City of Portsmouth  
Department of Public Works

Bid Proposal #30-06  
Shoreline Repairs Prescott Park and Four Tree Island  
**Addendum #1**  
**January 27, 2006**

This Addendum forms part of the original document marked Bid #30-06 Shoreline Repairs Prescott Park and Four Tree Island:

Alternate #1 Drain Line Modifications:

**PRESCOTT PARK SITE PLAN**

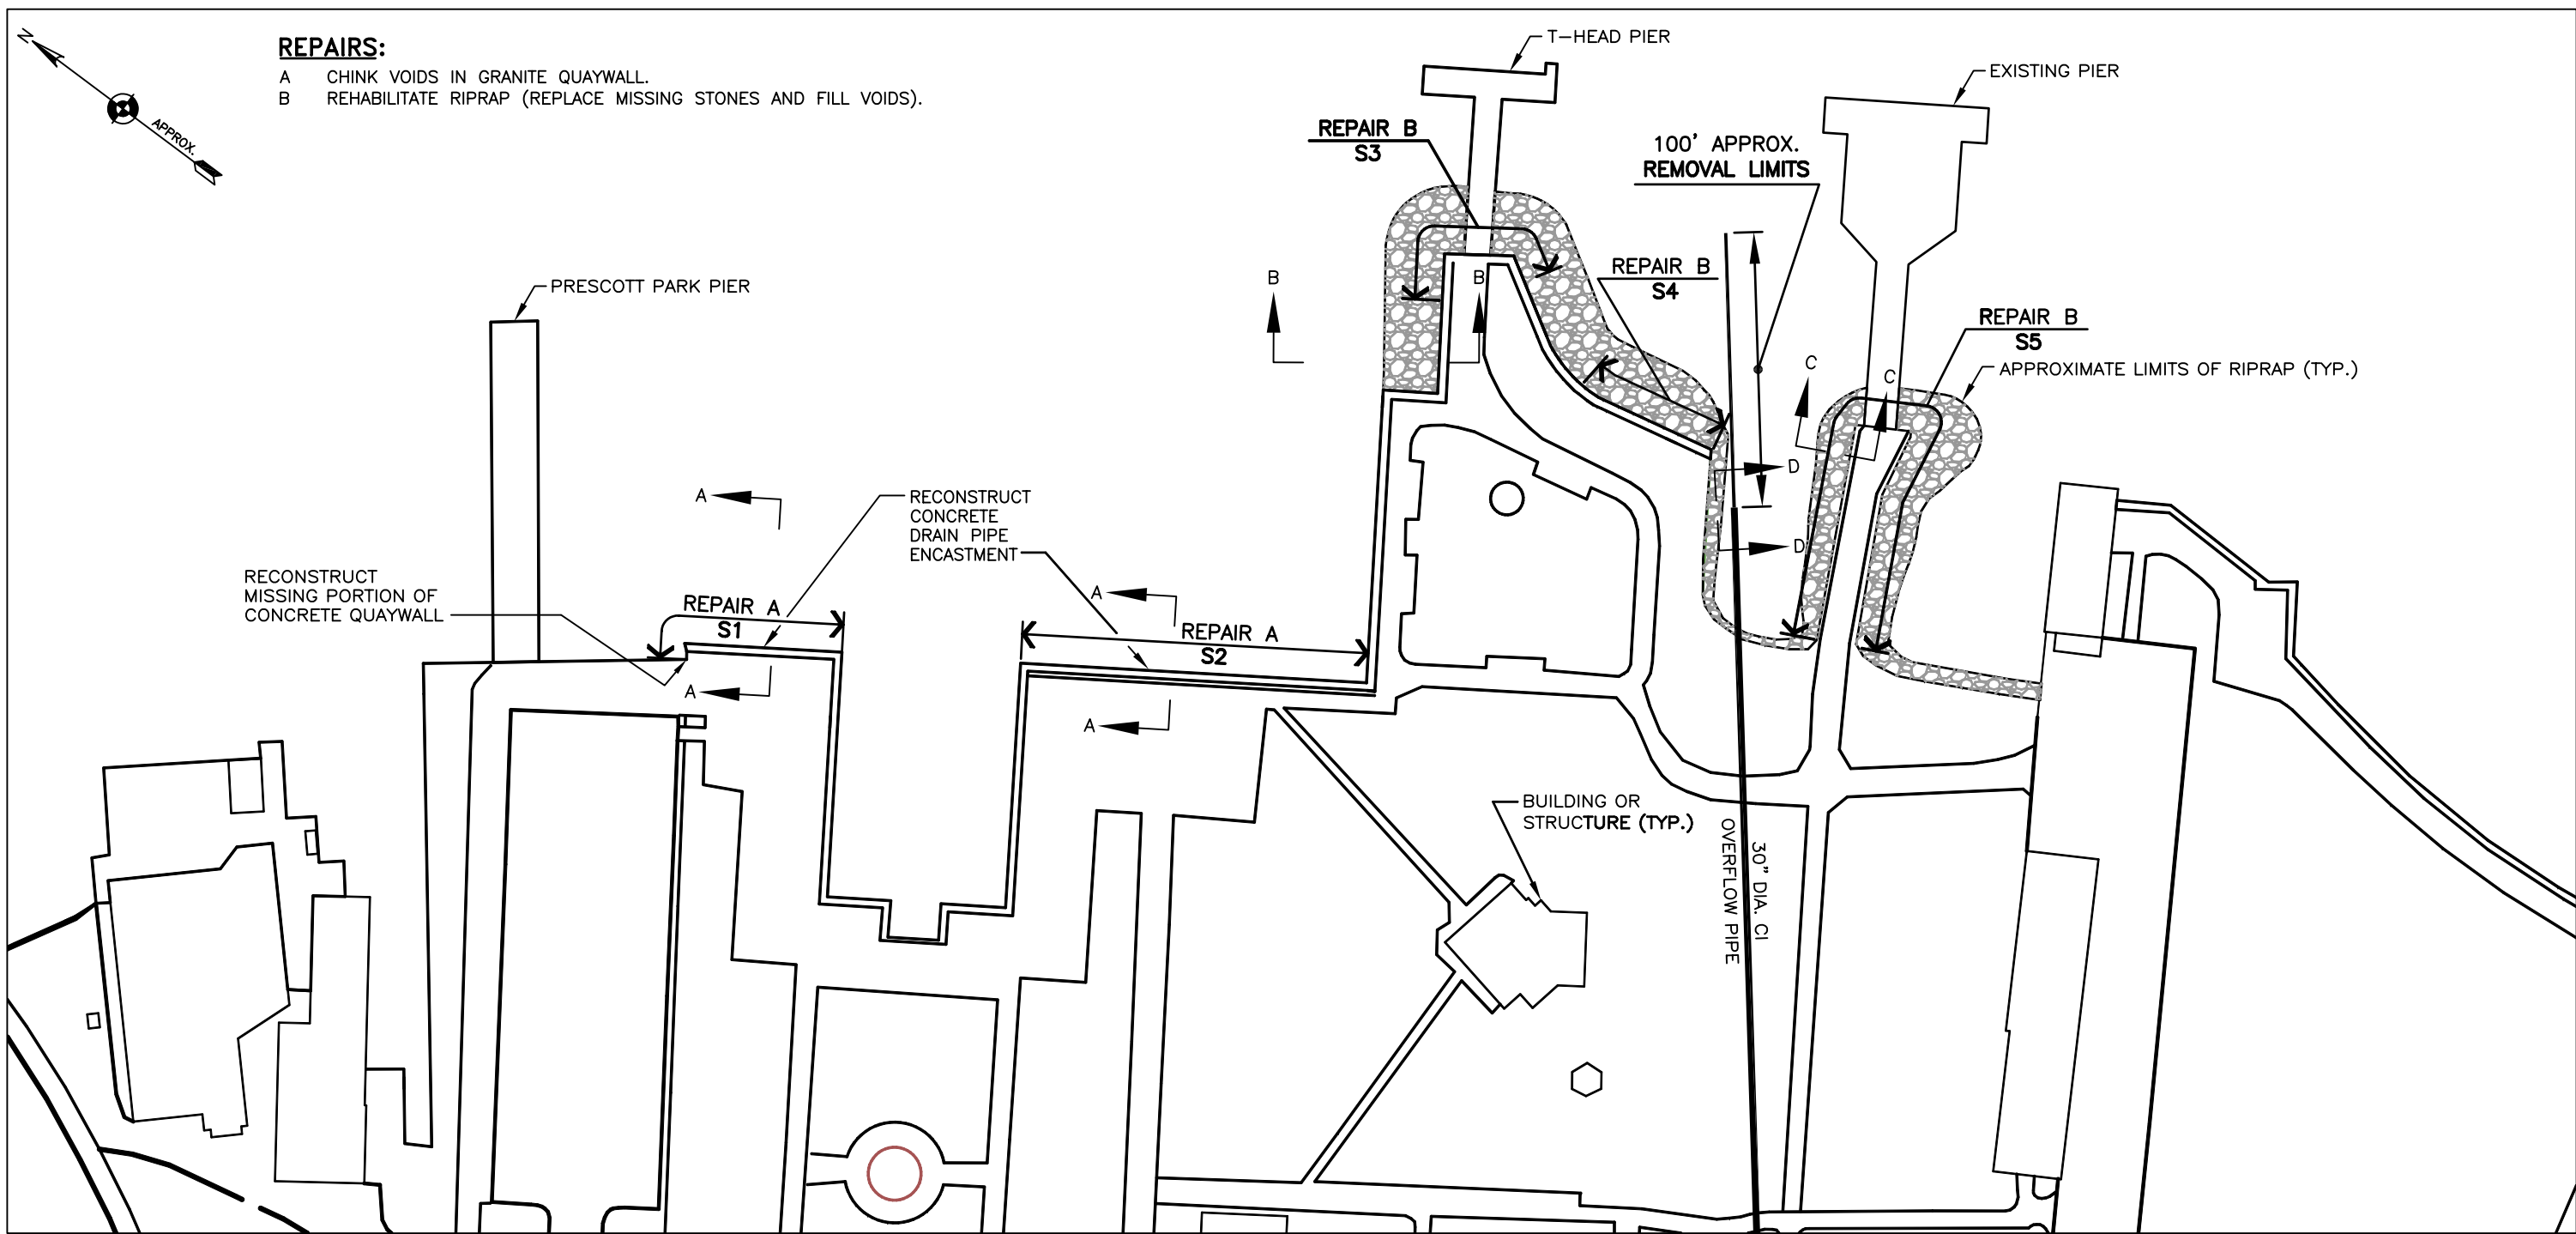
There is an old drain line extending into the river between T-Head Pier and the Existing Pier. This pipe consists of small sections of 30" Cast Iron pipe and is essentially lying on the river bottom. The proposed modifications consist of the following:

1. Excavate old 30" CI drain pipe from where it exits the ground at approximately mid-tide level to its termination near the end of the existing pier. (Approximately 100 LF)
2. This new termination shall be slip-lined with a 27" PVC pipe and mortared in place for a minimum length of 10'. Contractor to confirm the pipe size.
3. Rip Rap Class A shall be placed around the new out-fall to stabilize the structure in accordance with the Standard Details Sheet 2 of 3 entitled Prescott Park Sections.

100' APPROX. REMOVAL LIMITS

30" DIA. CI OVERFLOW PIPE
